Agenda - Council - July 22, 2009

Item No. 1 Concrete Sidewalk located behind Paul Martin Drive (Transcona Ward) File DASZ 12/2003

ISSUE: Minute No. 122 - DASZ 12/2003- Concrete Sidewalk behind Paul Martin Drive

Appendix “B” – Map of the Planned Area

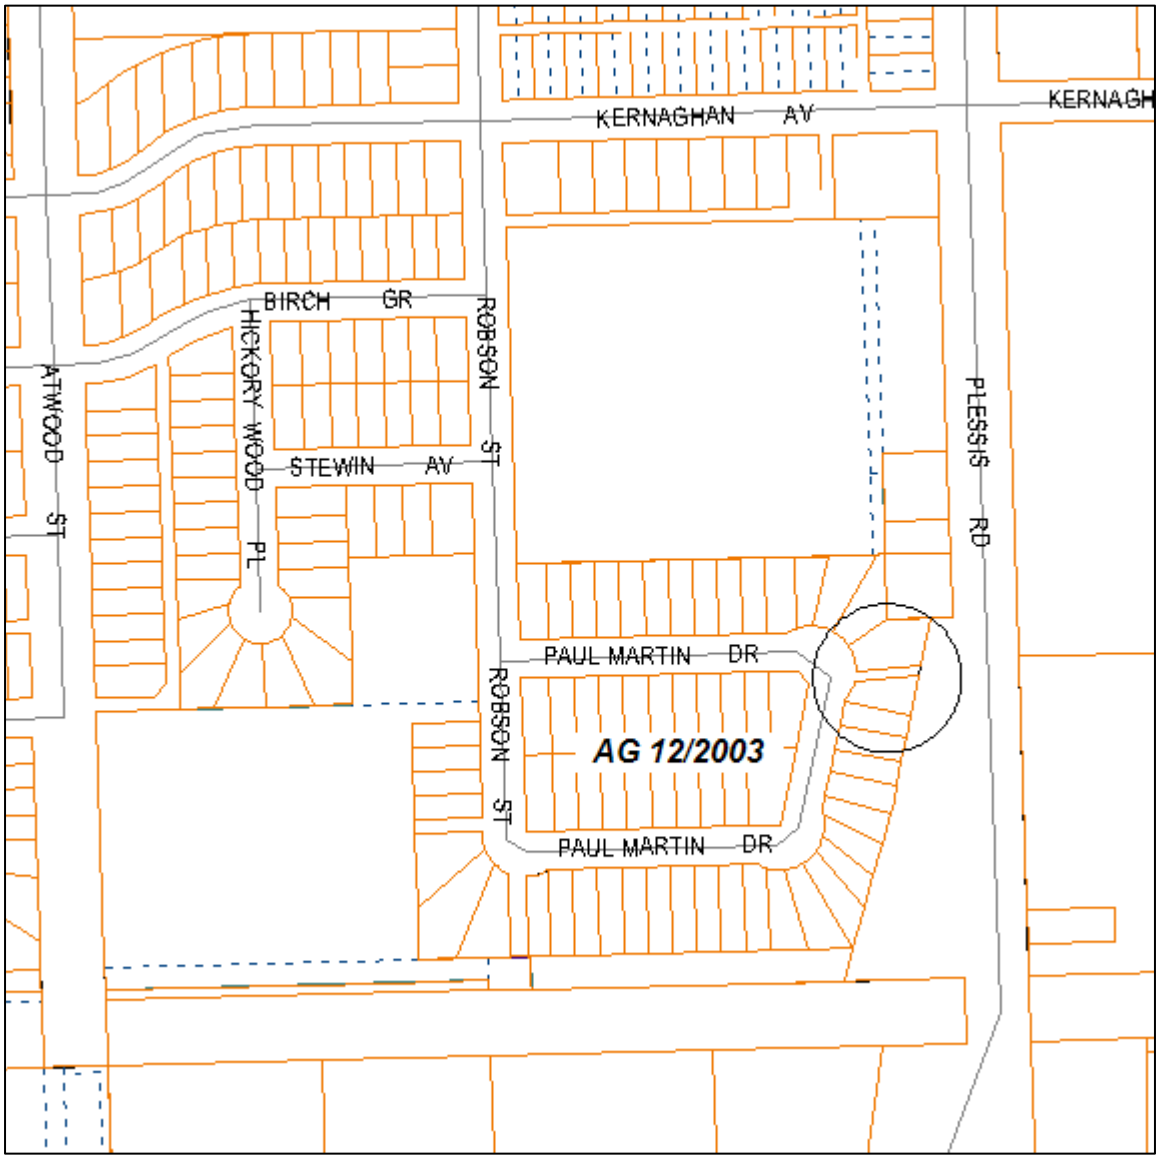
The Developer has dedicated the 4m strip to the public as a walkway but has not constructed the sidewalk within it (See Appendix "B" – Map of planned area). The east end of the walkway is currently closed with a fence. To satisfy the existing Development Agreement, a portion of the fence would need to be removed, fully opening the walkway to allow the Developer to construct the sidewalk.

Public Works would object to the deletion of the requirement for the pedestrian walkway noted below as it provides the only second means of access to this area and it provides pedestrian access to the sidewalk along Plessis Road and active transportation linkages. Perhaps Transit should also comment as this pedestrian walkway would provide more convenient access for Transit patrons who board and alight on Plessis Road.

The Transit Department concurs that the pedestrian walkway is required to accommodate passengers walking to/from bus stops on Plessis.

I guess my only comment is if the walkway is closed and sold to the adjacent owner(s), then we would require an easement for the full width of the closed walkway ROW.

In looking at the plan of the area I don't really see a need to retain this walkway as emergency secondary access. Because of the full loop I would not consider it a dead end type of situation.

Having not seen the design of the sidewalk/walkway it would be suggested that there be amble lighting for citizens who will be using the sidewalk/walkway.

1. That Condition No. 2 of Development Agreement AG 12/2003 be further amended by deleting the requirement for the Developer to construct a concrete sidewalk within the four (4) metre easement.
